Project Description: The applicant is requesting approval of a conditional use permit application for a 9,000 square-foot vehicle service business on 0.69-acres.

**Project/File:** **Blazek Diagnostic & Automotive / GC24-0007 / CUPFY2024-0006**  
This is a conditional use permit application for a 9,000 square-foot vehicle service business on 0.69-acres.

**Site address:** 3660 W Chinden Boulevard

Site Plan

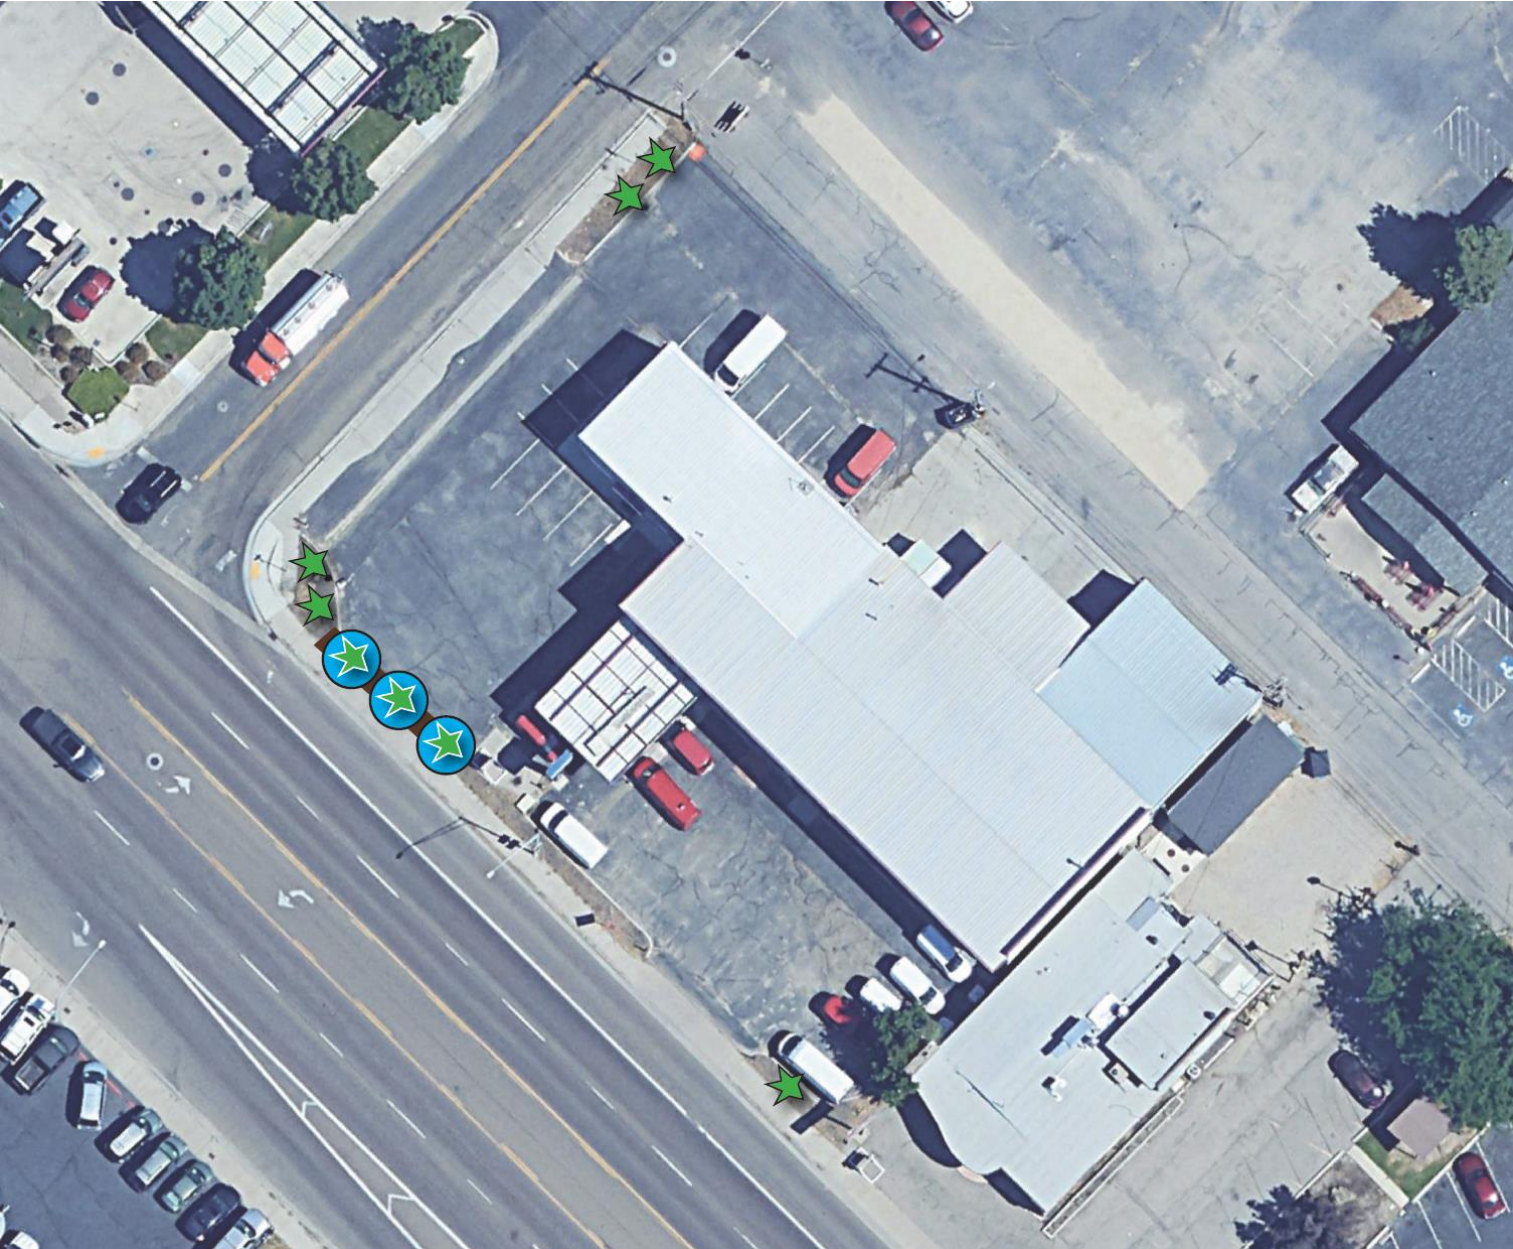
- a. **Existing Conditions:** There is an existing 15-foot wide paved alley, Osage Street, abutting the site's east property line running north/south between 37<sup>th</sup> Street and 36<sup>th</sup> Street.
- b. **Applicant Proposal:** The applicant is not proposing any improvements on Osage Street abutting the site.
- c. **Staff Comments/Recommendations:** The applicant's proposal does not meet District policy and should not be approved, as proposed. The applicant should be required to dedicate right-of-way to total 10-feet from centerline of the alley.

- a. **Existing Conditions:** There are two existing 24-foot wide curb-cut type driveways on 37<sup>th</sup> Street located 100-feet and 137-feet east of Chinden Boulevard (measured centerline to centerline).

- b. **Applicant's Proposal:** The applicant is proposing to maintain both driveways.
- c. **Staff Comments/Recommendations:** The applicant's proposal does not meet District Driveway Location policy which requires driveway to be located 150-feet from arterial roadways and should not be approved, as proposed. The applicant should be required to close the existing 24-foot wide driveway located 100-feet east of Chinden Boulevard with vertical curb, gutter, and 5-foot wide attached concrete sidewalk to match the improvements on either side. Typically, the applicant should also be required to close the 24-foot wide driveway located 137-feet east of Chinden Boulevard as it does not meet District Driveway Location Policy. However, staff recommends the driveway remain located where is currently is, but be reconstructed in accordance with PROWAG to accommodate concerns regarding site circulation.

2. Dedicate right-of-way to total 10-feet from centerline of the alley.
3. Install “No Parking” signs at the 37<sup>th</sup> Street/Osage Street intersection.

4. Provide 20-feet of back-up space from any parking structure to the back of the alley.
5. Close the existing 24-foot wide driveway located 100-feet east of Chinden Boulevard with vertical curb, gutter, and 5-foot wide attached concrete sidewalk to match the improvements on either side.

6. Reconstruct the existing 24-foot wide driveway located 137-feet east of Chinden Boulevard in accordance with PROWAG.
7. Submit civil plans to ACHD Development Services for review and approval. The impact fee assessment will not be released until the civil plans are approved by ACHD.
